Small Lot Housing Code

Stage 2 - Standards Review (SLHC2)

**SMALL LOT HOUSING CODE - STAGE 2 STANDARDS REVIEW
SUBMISSION**

Figure 1 - Type C Setbacks vs. Buildable Footprint 80m² Lot.
Front loaded typologies precluded by setbacks and buildable envelope.

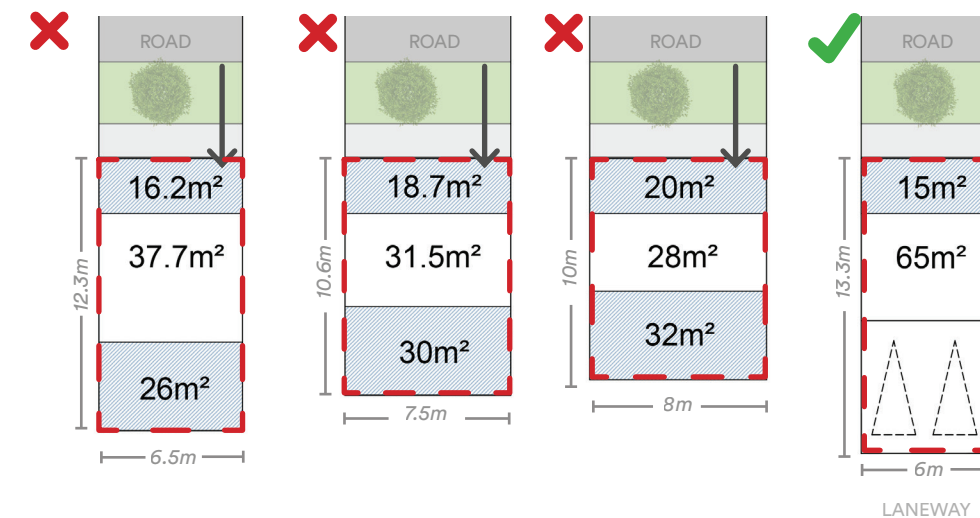
The Type C provisions are also considered to heavily favor rear accessed lot typologies, with lots accessed via a street frontage imposed with building envelopes which are not sufficient for viable design outcomes. If we consider a 80m² micro lot typology, applying 'standard' medium density frontages ranging from 6m through to 8m (noting some Council's will seek a minimum frontage of 7- 7.5m for front accessed dwellings), the setback requirements as identified in Figure 1 will preclude the delivery of front loaded product from two key perspectives - the buildability of the remaining ground floor envelope and the inability for the envelope to deliver a depth to the garage in accordance with the proposed Standard 15.4 provisions.

Figure 2 - Type C Setbacks vs. Buildable Footprint 100m² Lot.
Ground floor footprint less than Type B opportunity.

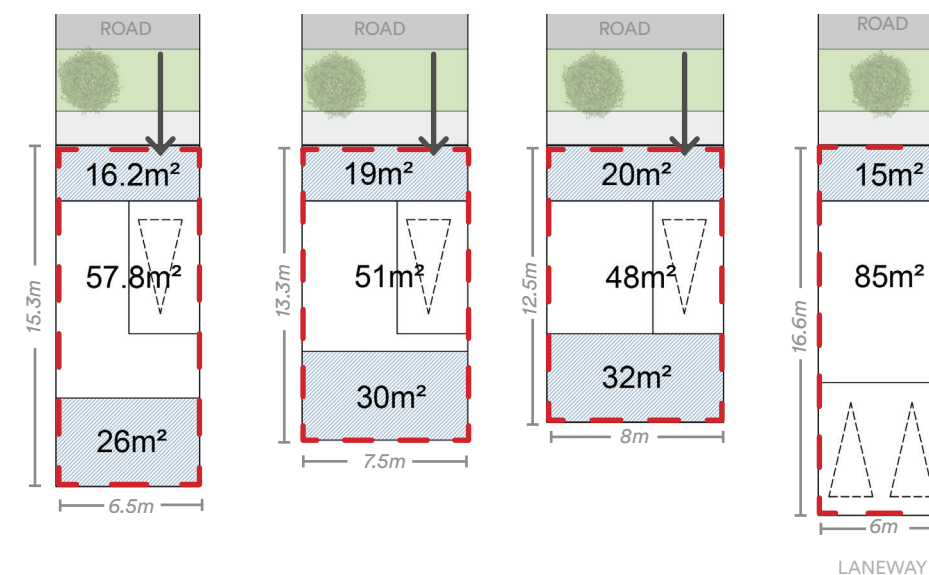
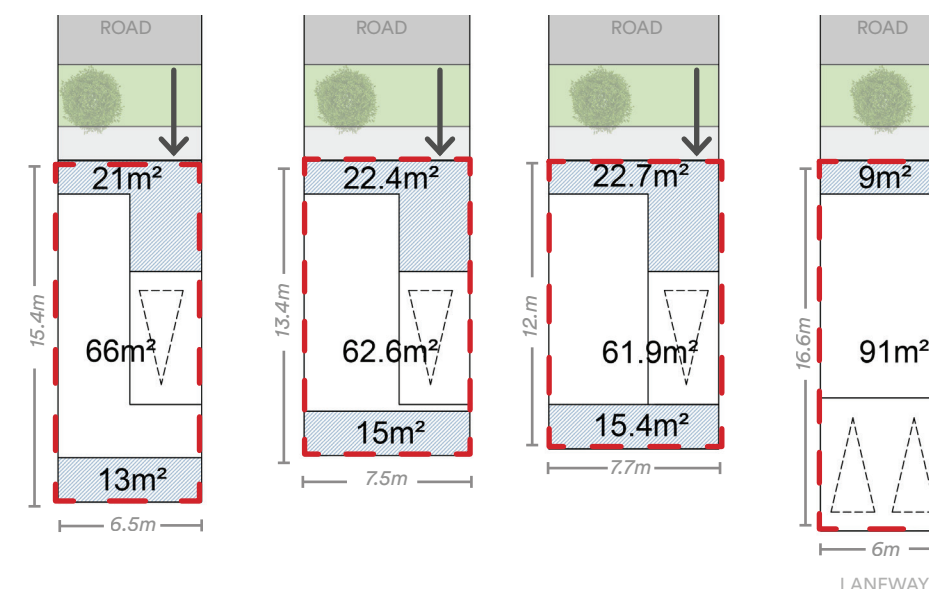
When considering a 100m² micro lot typology, there is the ability to deliver a front loaded dwelling, however as can be seen in Figure 2 and 3 which provide a comparison between Type C and Type B provisions, Type C provisions are more onerous with less ground floor area available.

Figure 2 also highlights that for Type C product the wider the frontage, the greater the impact to the buildability of the lot. This is considered counter intuitive to the design principle of reducing garage dominance through wider frontages, which is a key growth area concern with SLHC product and inherently directs design outcomes to pursue narrower lot widths in order to minimise setback impacts and improve the buildability of the lot.

Figure 4 - Typical Rear Loaded Laneway with No Rear Splay

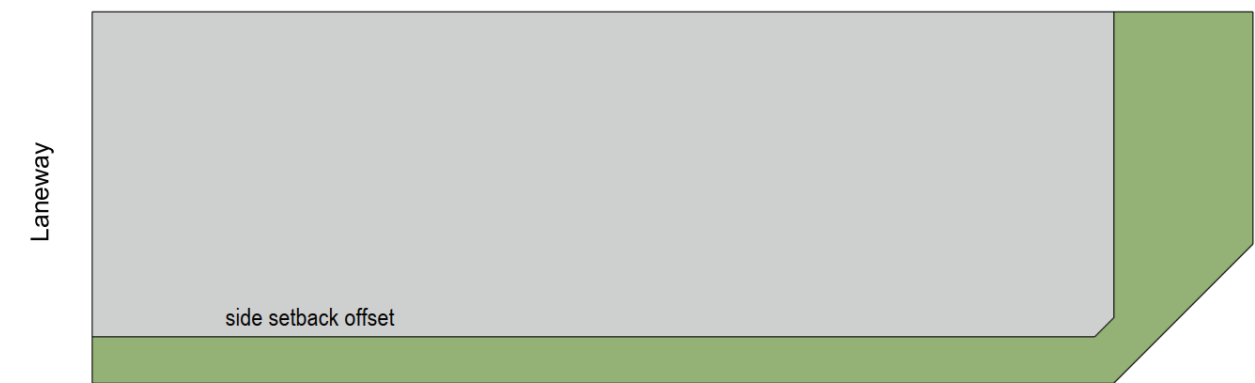
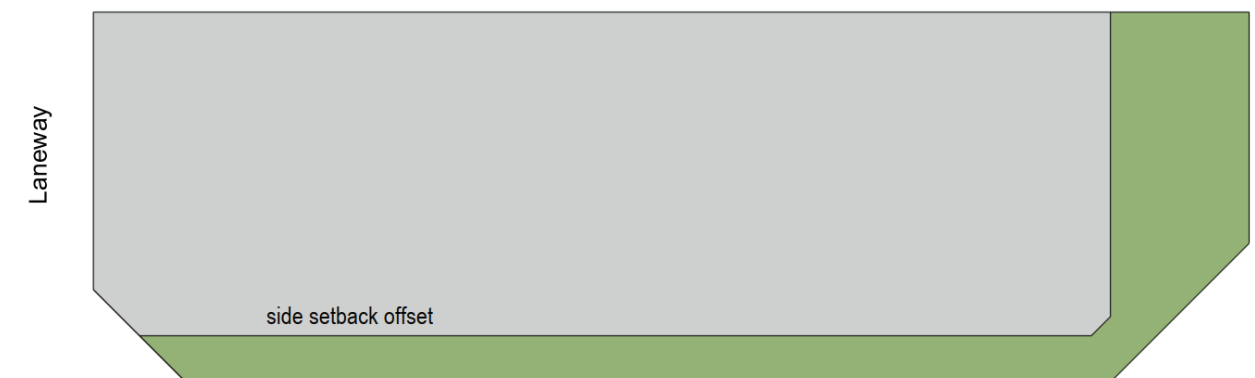
Clarification of side setback interface to rear splay laneway typologies in accordance with previous interpretation provisions by VPA.

- Rear loaded laneway lot typologies differ across Councils with some requiring rear splay truncations whilst others don't.
- This can result in differing requirements depending on interpretation which ultimately results in significant discrepancy in corner lot size and design impacting consistency between municipal areas and creating disparity in affordability for 'like for like' corner product.

- Provide additional note and two diagrams to Standard 2.1 Practice Notes/Code that clearly articulate side setback offset alignments for corner rear loaded laneway lots, with or without rear splay truncations.
- Side setback to be permitted to run directly into rear splay interface to provide consistency for all rear loaded laneway lot typologies in line with current Practice Note - Diagram 3 (Standard 2.1).
- For allotments that directly abut or side a public reserve, Standard 2.1 (Table 1) side setbacks are to apply.

Figure 11 - Impact to design and balcony amenity when Standard 7 setback is applied to balcony offset from both side

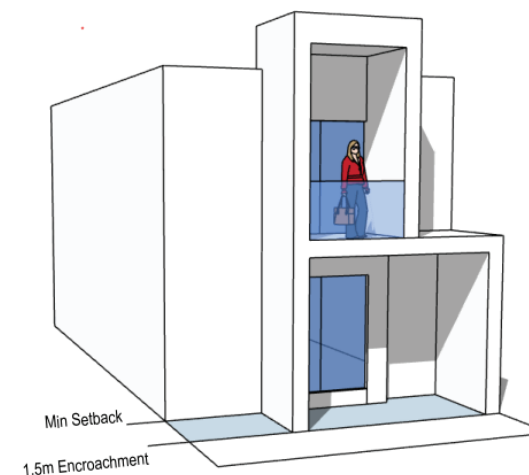
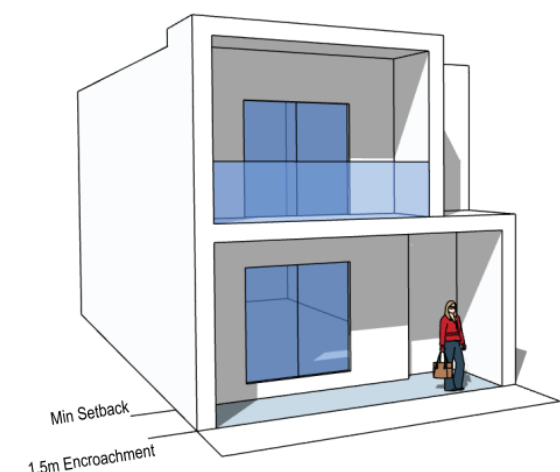
- Application of Standard 7 Side and Rear setback controls is also onerous to balcony structure particularly with simultaneously approved or 'row' housing significantly constraining design flexibility and façade diversity.

- Incorporating wall on boundary projection forward of the front facade is currently required to ensure standard 7 is not applied to balconies, otherwise significant side setbacks are applied. This provides limited flexibility and counterintuitive to, delivering design diversity.

- Remove reference and controls to roofed or unroofed balconies and projections in 2.5(b). Allowing balconies whether roofed or unroofed to project up to 1.5m into front setback (as per other articulation elements in revised 2.4a).
- Balconies to project a minimum 800mm from front wall. Remove reference to projection no more than 1.5m forward of front wall as this is controlled by revised 2.5(b) noted above.
- Balcony elements including supporting structure and/ or walls can encroach into the front setback as specified in revised 2.5(b) and are to be exempt from 'Standard 7' Side and Rear setback provisions.

Figure 14 - Revised Diagram 11b - Standard 7 Reduced Side and Rear Setback Profile

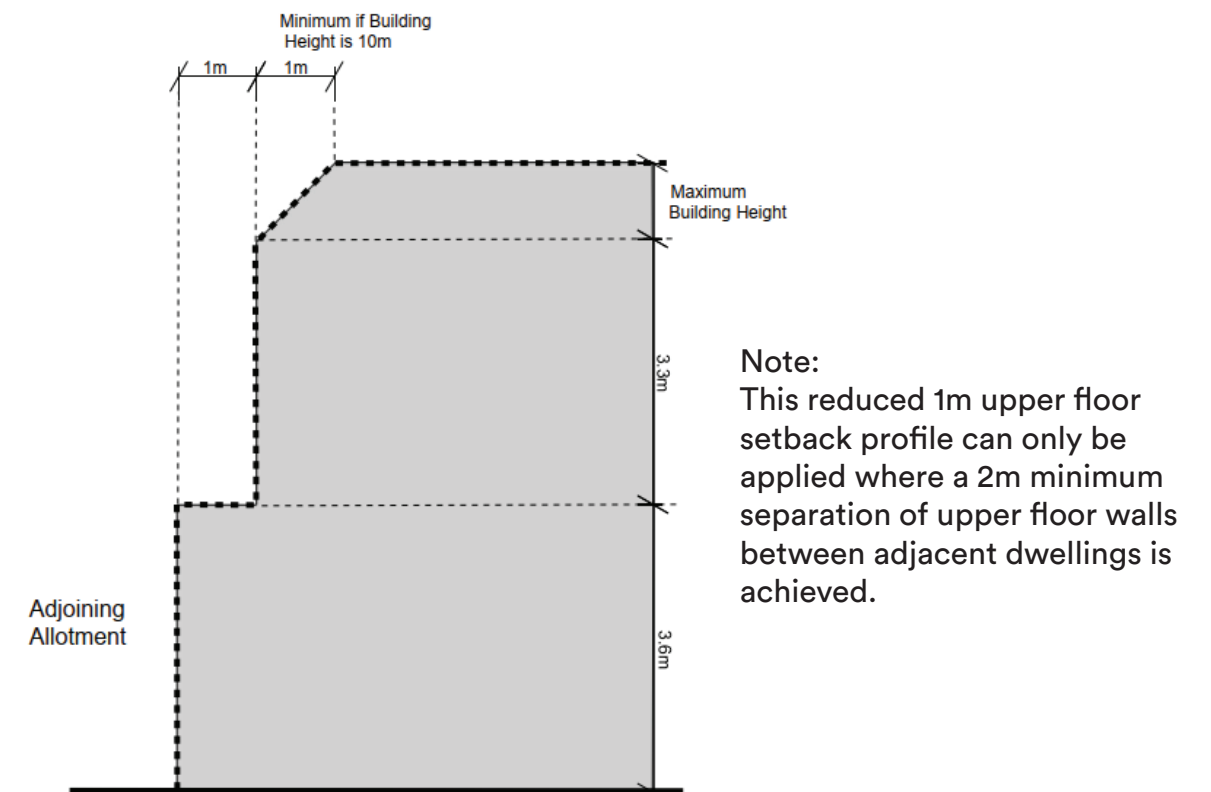
- Current controls are onerous and essentially penalise SLHC designs that adopt upper floor side setbacks imposing 'ResCode' type side setbacks. This encourages boundary to boundary upper floor development a reduces opportunities for product amenity to upper floors. This will also assist with proposed NCC changes.

- The proposed butterflyed 1m side setbacks from each lot boundary would provide an adequate 2m minimum wall separation for urban product as well as provide 'clear to sky' allowance to windows, similar to what is currently entertained at a ground floor.

- Provide a sub provision to Standard 7.1(a) (and/or add to table 6) – A reduced side setback of 1m for walls up to 6.9m in height can be applied provided the adjacent lot also adopts the matching setback profile to assure a 2m separation to upper floor walls between dwellings is achieved (Refer to Figure 14).
- Side setback controls to not apply to articulation elements such as balconies, verandahs, porches, pergolas and blade walls may be located anywhere within revised building envelope profile and can encroach into the front setback by 1.5m.
- Consider for simultaneously approved dwellings the ability for roof form to extend above envelope profile provided effective wall height at ceiling level is under 6.9m for two store dwellings, this will provide greater opportunity for design and roof form variation.

Figure 15 - Example of 1m side setback allowance for walls up to 6.9m high provided adjacent lot also applies the same profile to achieve a minimum 2m wall separation between dwellings.

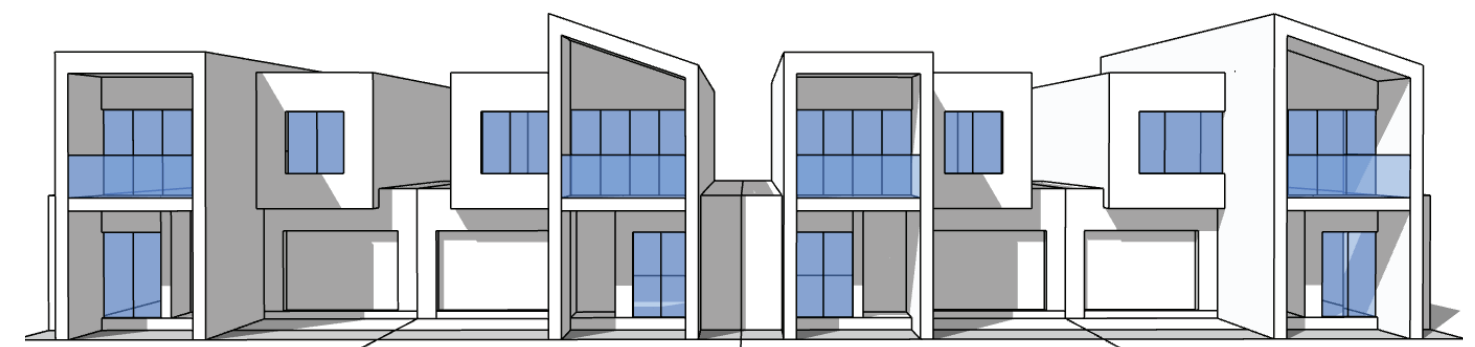
- Proposed changes will encourage and facilitate an increase in semi detached and detached housing typologies, which will also facilitate streetscape outcomes with reduced massing, relief and diversity in built form (Refer to Figure 15).

Figure 16 - Revised Diagram 12 - Standard 8
Side and Rear Setback Profile - Where a laneway or adjoining lot is approved on boundary
Type A and B

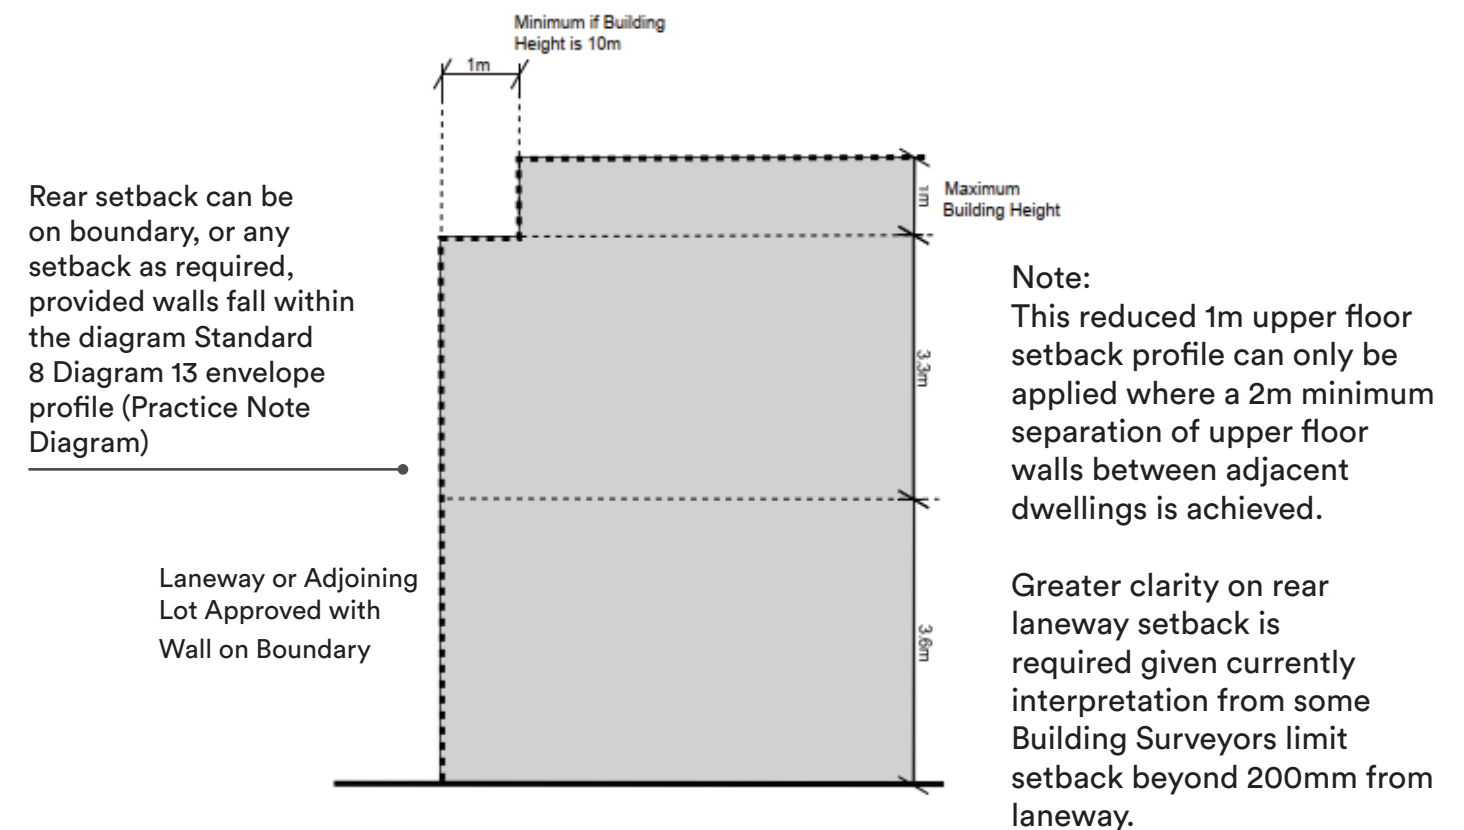
- Reinstating 0-200mm wall on boundary allowance allows for individual abutting wall construction methodology (which requires a small gap between adjacent buildings) and facilitates gutter on boundary construction methodology utilised by the majority of builders on detached or semi detached product.

- This profile is suggested to apply to any row housing and simultaneously approved dwellings with abutting walls, permitting roof forms, balcony, verandas, porches, pergolas and other articulation elements to be located anywhere within this building envelope profile/ zone. This provides improved design flexibility, product identity and encourages façade diversity.

- Reinstate 0-200mm allowance for wall on boundary (definition).
- Revised side setback envelope profiles for walls on boundary (Diagram 12) noting the 1m upper floor setback can only be applied where the adjacent lot also adopts the matching setback profile to assure a 2m separation of upper floor walls between dwellings is achieved.
- Side setback profiles to not apply to articulation elements such as balconies, verandas, porches, pergolas and blades walls (Standard 2) and may be located anywhere within the building envelope profile and can encroach into the front setback by up to 1.5m.
